Project	<b>IEEE 802.16 Broadband Wireless Access Working Group</b> < <a href="http://ieee802.org/16">http://ieee802.org/16</a> >
Title	<b>IEEE 802.16m System Deployment Scenarios with Multi-carrier Support and Clarification on Multi-carrier Frame Structure</b>
Date Submitted	<b>2008-09-05</b>
Source(s)	I-Kang Fu, Yih-Shen Chen, Kelvin Chou, <a href="mailto:IK.Fu@mediatek.com">IK.Fu@mediatek.com</a> Dora Chen, Stanley Hsu, Pei-Kai Liao, Yu-Hao Chang, Paul Cheng MediaTek Inc.  No.1, Dusing Rd. 1, Hsinchu Science Park, Hsinchu, Taiwan, R.O.C.
Re:	802.16m-08/033, "Call for Contributions and Comments on Project 802.16m System Description Document (SDD)," ◆ PHY: Multi-Carrier Operation
Abstract	This contribution investigates the possible scenario for IEEE 802.16m network deployment. Due to the restriction by backward compatibility when co-deployed with IEEE 802.16e network, the frequency channel bandwidth, center frequency and channel raster shall be the same as the parameters used in IEEE 802.16e based mobile WiMAX system.

# Multi-carrier Transmission Scheme and the Clarification on Multi-carrier Frame Structure for IEEE 802.16m

*I-Kang Fu, Yih-Shen Chen, Kelvin Chou, Dora Chen, Stanl

Figure 5 Confusion on the definition on multi-carrier MS and wider bandwidth MS due to the confusing drawing in current SDD

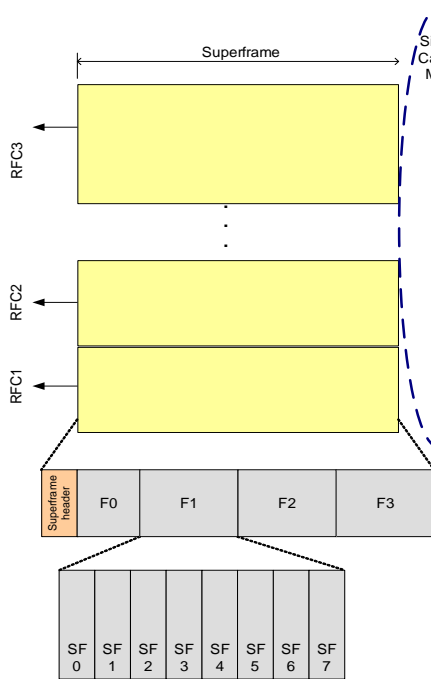
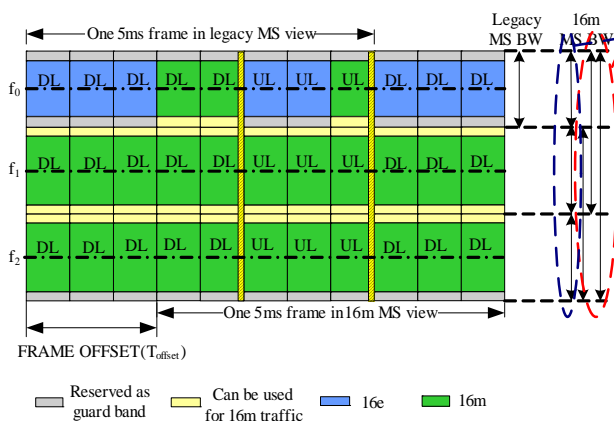
Consider the case depicted in Figure 4, it's very confusing that whether the multi-carrier frame structure or the frame structure with wider bandwidth support should be applied? Figure 5 put the current figures in SDD for comparison to show how people may confuse on the definitions on "multi-carrier" and "wider bandwidth".

The drawing for multi-carrier MS in Fig.18 is the same as the drawing for 16m MS with wider BW support.

This will definitely confuse people the definitions on "multi-carrier" and "wider bandwidth"

The drawing for single carrier MS in Fig. 18 is also the same as the 16m MS with wider BW support in Fig. 22.

This will confuse people what is the definition of "wider bandwidth"

Figure 18 Example of the proposed frame structure to support multi-carrier operation

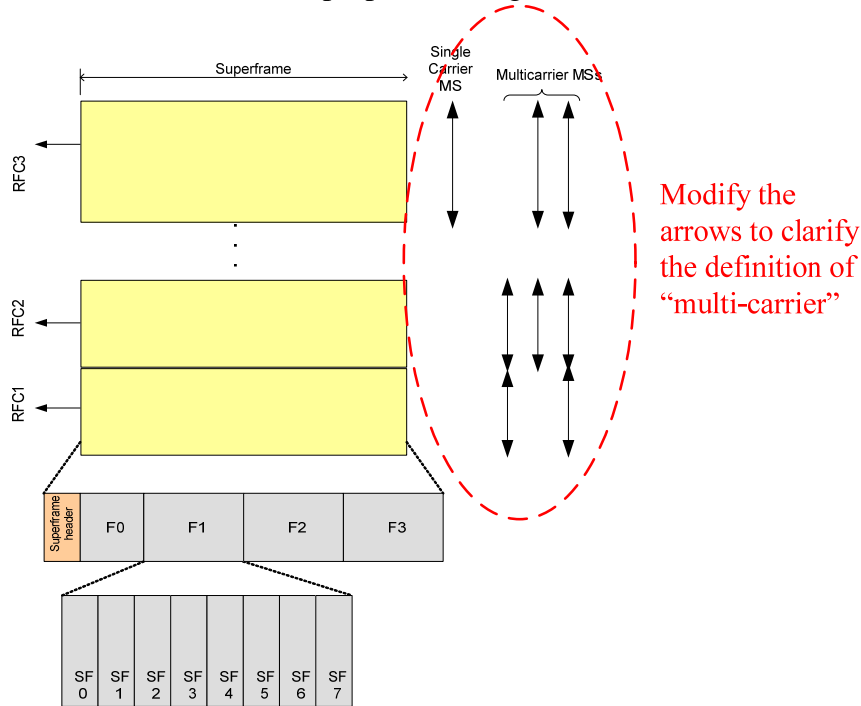
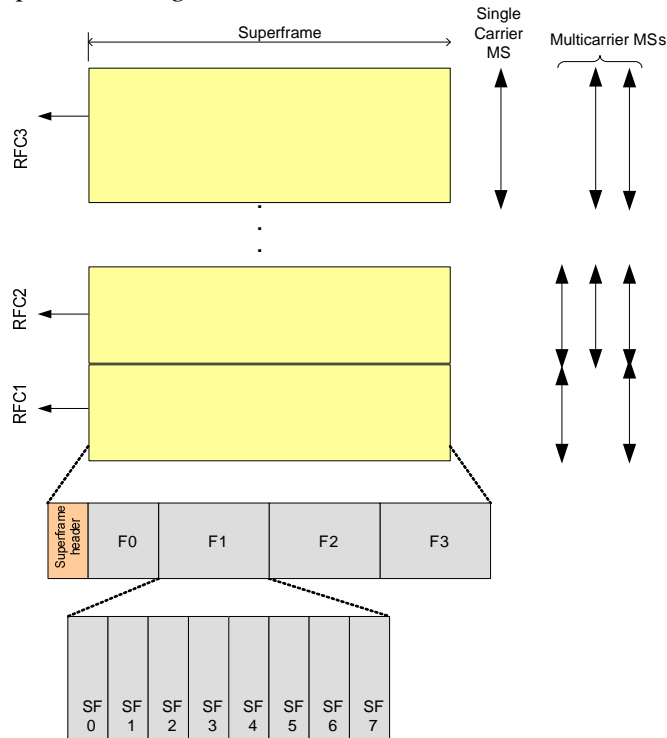
In addition to the confusion on multi-carrier MS and the MS with wider bandwidth support, the frame structures will also confuse people what is the meaning of the wider bandwidth support. Because both Figure 18 and Figure 22 in SDD specifies multiple frequency channels, and both of them actually looks like multi-carrier frame structure. A simple method to resolve the confusion is adding the lines to indicating the 16m BS bandwidth in the frame structure with wider bandwidth support. This can help people understand the definition of wider bandwidth defined in IEEE 802.16m.

In order to resolve the confusions in current SDD without largely revise the current SDD text, the slightly modified frame structures is proposed in Figure 6 for clarification.

[Use the following figure to replace the Figure 18 in 802.16m-08/003r4]

Figure 18 Example of the frame structure to support multi-carrier operation
